**SINSW - GLENWOOD HIGH SCHOOL
RESPONSE TO SUBMISSION**

Thank you for your email dated 23 December 2021, requesting the review and preparation of written responses to address concerns raised pertaining to the **SSD-23512960 - Glenwood High School Upgrade**.

Appendix 1
Drawing amendments

Drawing Number
DA-LA-0002a

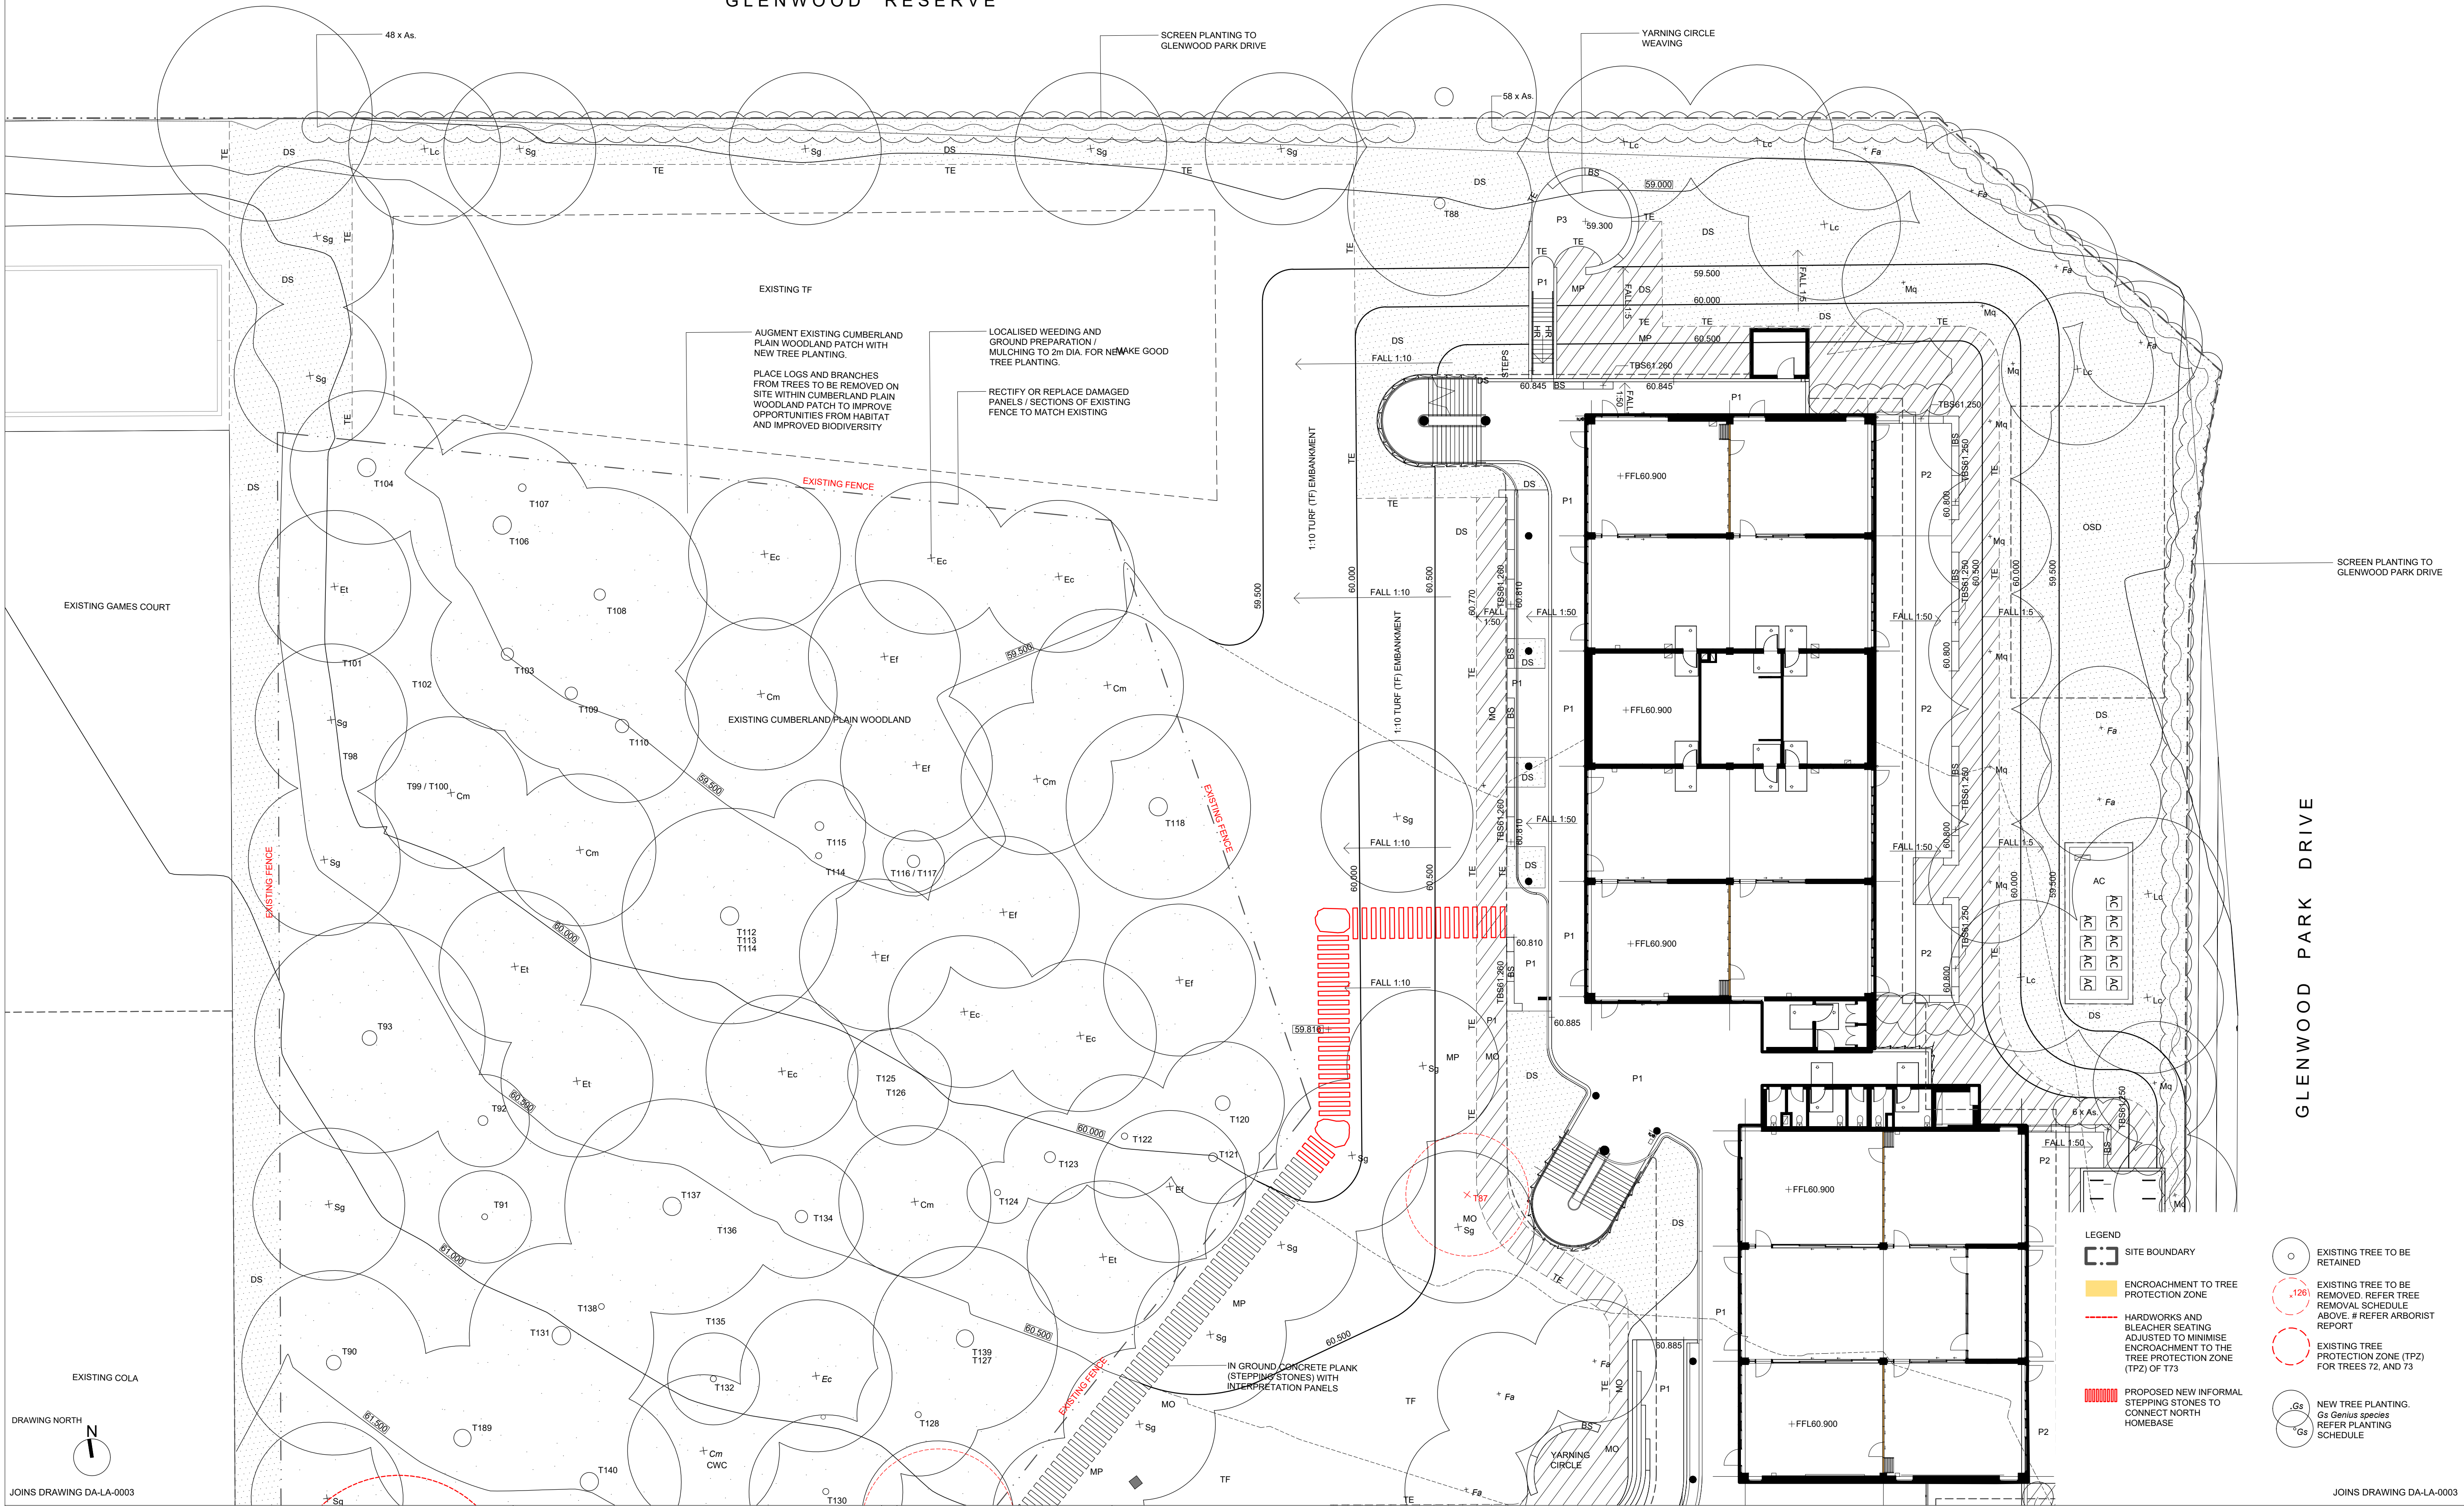
The report states that 'one high retention value tree (Tree 73) will be subject to high Impact from SSD works. There may be possibility for design changes which could allow for the retention of this tree however the current design does not allow this tree to be retained.' EES notes that the actual level of encroachment into the tree protection zone (TPZ) of the tree has not been documented in the report, however if there is potential for this tree to be retained and protected, this should be further explored.

A major encroachment into the TPZ of Tree 72 is also proposed under the subject SSD. The exact extent of encroachment is unclear however the report notes the tree may be retained subject to specific construction methodologies and timing of works. Further clarity should be provided regarding the actual measures required to retain and protect this tree.

Why the footpath has not been reinstated forming a pedestrian connection between end points of the new 'L' shaped building.

McIntosh & Phelps has developed design iterations to the existing design currently encroaching on the Tree Protection Zone (TPZ) of Tree 73 - *Eucalyptus tereticornis* (Forest red gum). The proposed design amendment option (Refer Appendix 1) minimises the encroachment to Tree 73 from 20% to 8.44% and should allow the tree to be retained.

The encroachment of the TPZ of Tree 72 - *Eucalyptus tereticornis* (Forest red gum) is 10.4% (Refer Appendix 1). Construction methodologies to reduce the impact on the TPZ identified by Eco-Logical could include;

McIntosh & Phelps has now proposed to increase stepping stone path linking the proposed new homebases to the north (Refer Appendix 1)
